## 4.0L ENGINE BELT SQUEAL OR CHIRP NOISE ON COLD STARTUP

TSB 09-7-7

2009 Mustang  
2007-2008 Explorer Sport Trac, Explorer

2007-2008 Mountaineer

Figure 1 - Article 09-7-7

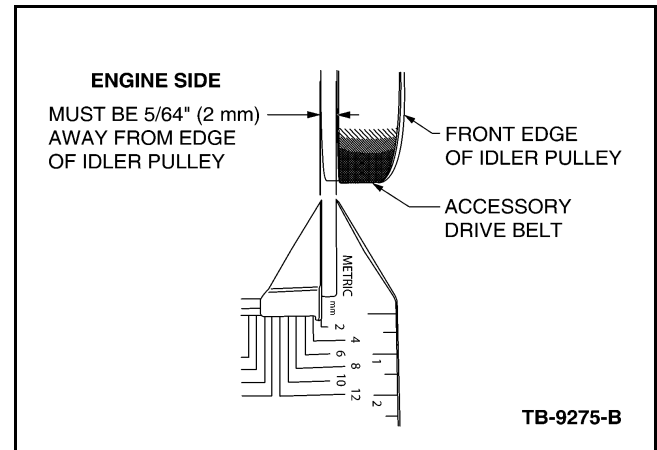
1. Visually inspect all related FEAD components for damage and or abnormal wear. Reference the online Work Shop Manual (WSM), Section 303-05. If no concerns found, proceed to Step 2.
2. Inspect for FEAD belt clearance on the idler pulley. A properly aligned belt will have an approximate  $3/32''$  (2 mm) space behind the belt on the idler pulley. (Figure 1)
3. Verify the generator bracket and idler pulley are properly seated and torqued to specification. Reference the online (WSM), Section 303-05.
  - a. If there is not an approximate  $3/32''$  (2 mm) gap, proceed with Step 3.
  - b. If there is an approximate  $3/32''$  (2 mm) gap, proceed with Step 5.
4. Replace the generator bracket with updated bracket. Reference online (WSM), Section 303-01. Proceed to Step 5.

- 5. Replace the accessory drive belt with the updated belt part number. Reference online (WSM), Section 303-05.
